Dominion Energy Kewaunee, Inc.  
5000 Dominion Boulevard, Glen Allen, VA 23060  
Web Address: www.dom.com

**DOMINION ENERGY KEWAUNEE, INC.**  
**KEWAUNEE POWER STATION**  
**LICENSE AMENDMENT REQUEST 256, PERMANENTLY DEFUELED LICENSE**  
**AND TECHNICAL SPECIFICATIONS**

**DISCUSSION OF CHANGE, TECHNICAL ANALYSIS, SIGNIFICANT HAZARDS  
DETERMINATION, AND ENVIRONMENTAL CONSIDERATIONS**

Figure 3.7.15-1 (page 1 of 1)  
Fuel Assembly Burnup Limits in the Spent Fuel Pools

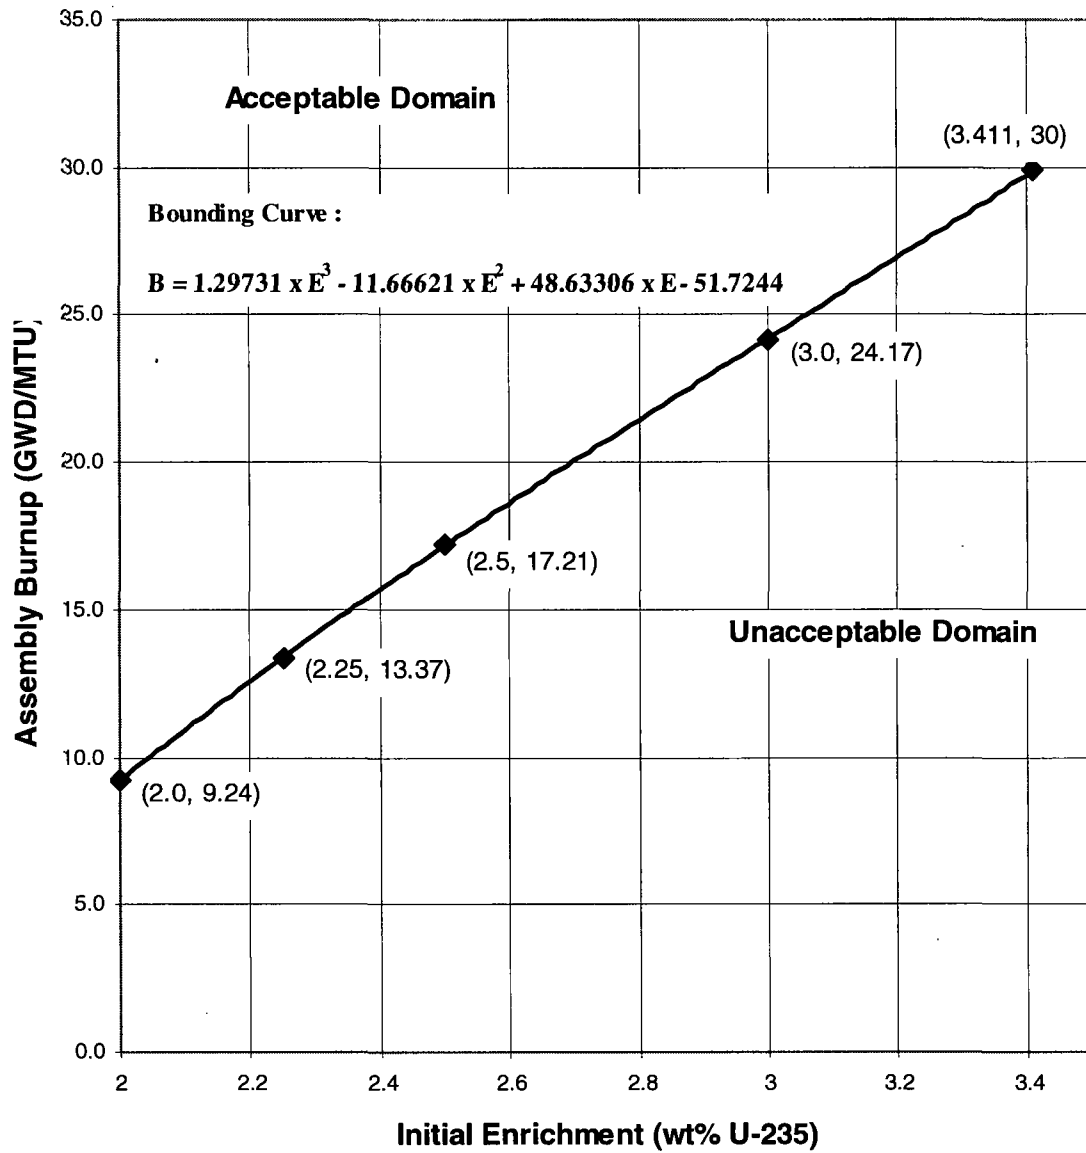
TS 3.7.15, "Spent Fuel Pool Storage," specifies restrictions on the placement of fuel assemblies within the spent fuel pool, in accordance with Figure 3.7.15-1 in the accompanying LCO to ensure the  $k_{\text{eff}}$  of the spent fuel pool will always remain  $< 0.95$ , assuming the pool to be flooded with unborated water. Irradiated fuel assemblies discharged prior to or during the 1984 refueling outage with a combination of burnup and initial nominal enrichment in the Acceptable Domain of Figure 3.7.15-1 are allowed to be stored in the transfer canal spent fuel pool or the north and south combined spent fuel pools. New fuel assemblies, irradiated fuel assemblies discharged after the 1984 refueling outage, or spent fuel assemblies not in the Acceptable Domain of Figure 3.7.15-1 shall be stored in the north and south pools (combined).

- a. Irradiated fuel assemblies discharged prior to or during the 1984 refueling outage with a combination of burnup and initial nominal enrichment in the "Acceptable Domain" of Figure 3.7.15-1 shall be stored in the transfer canal spent fuel pool or the north and south combined spent fuel pools; and

- b. ~~New fuel assemblies, irradiated fuel assemblies discharged after the 1984 refueling outage, and irradiated fuel assemblies discharged prior to or during the 1984 refueling outage with a combination of burnup and initial nominal enrichment in the "Unacceptable Domain" of Figure 3.7.15-1, shall be stored in the north and south combined spent fuel pools.~~ Irradiated fuel assemblies discharged after the 1984 refueling outage, and irradiated fuel assemblies discharged prior to or during the 1984 refueling outage with a combination of burnup and initial nominal enrichment in the "Unacceptable Domain" of Figure 3.7.15-1, shall be stored in the north and south combined spent fuel pools.
